HISTORIC AND DESIGN REVIEW COMMISSION

November 16, 2022

HDRC CASE NO: 2022-548
ADDRESS: 218 WASHINGTON ST
LEGAL DESCRIPTION: NCB 739 BLK 2 LOT 4 5 & 6
ZONING: RM-4, H
CITY COUNCIL DIST.: 1
DISTRICT: King William Historic District
APPLICANT: Anne Toxey
OWNER: Anne Toxey
TYPE OF WORK: Repair and reconstruction of the rear accessory structure
APPLICATION RECEIVED: October 24, 2022
60-DAY REVIEW: Not applicable due to City Council Emergency Orders
CASE MANAGER: Rachel Rettaliata

The applicant is requesting a Certificate of Appropriateness for approval to replace the original barrel tile metal roof with a galvalume standing seam metal roof.

① Roof Framing Plan
1/8" = 1'-0"

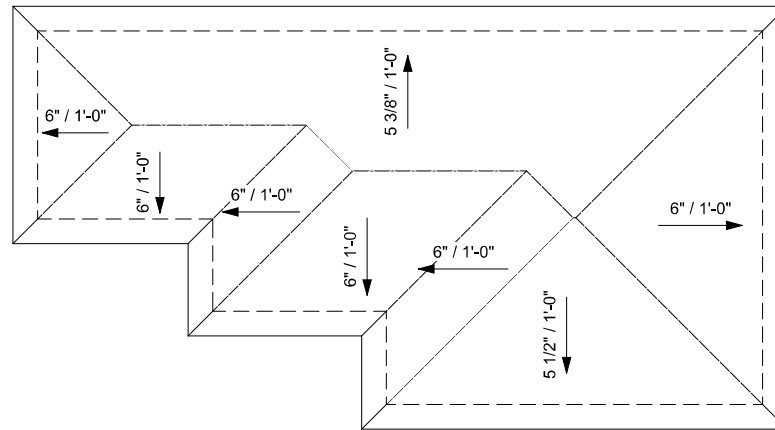
- b. The applicant has proposed to replace the existing barrel tile metal roof with a standing seam metal roof to match the roof on the primary structure. Guideline 3.B.iv for Exterior Maintenance and Alterations states that roofing materials should be replaced with in-kind materials whenever possible when the roof must be replaced. Historic materials such as slate or clay tiles should be retained and re-used when large-scale replacement of roof materials other than asphalt shingles is required. The existing metal roof tiles are severely damaged and require replacement. Furthermore, Guideline 3.B.iv states that new roofing materials should match the original materials in terms of their scale, color, texture, profile and style or materials should be selected that are consistent with the building style when in-kind replacement is not possible. The primary structure originally featured barrel tile roofing. Staff finds the request is inconsistent with the Guidelines. Staff finds that the installation of a material that is similar in appearance to the existing tile would be appropriate.

Staff does not recommend approval based on findings a through b. Staff recommends that the roof is replaced with in-kind materials or a material similar in appearance to the existing tile.

- i. That the applicant installs a standing seam metal roof featuring panels that are 18 to 21 inches wide, seams that are 1 to 2 inches high, a crimped ridge seam, and a standard galvalume finish. Panels should be smooth without striation or corrugation. Ridges are to feature a double-munch or crimped ridge configuration; no vented ridge caps or end caps are allowed. An on-site inspection must be scheduled with OHP staff prior to the start of work to verify that the roofing material matches the approved specifications. All chimney, flue, and related existing roof details must be preserved.
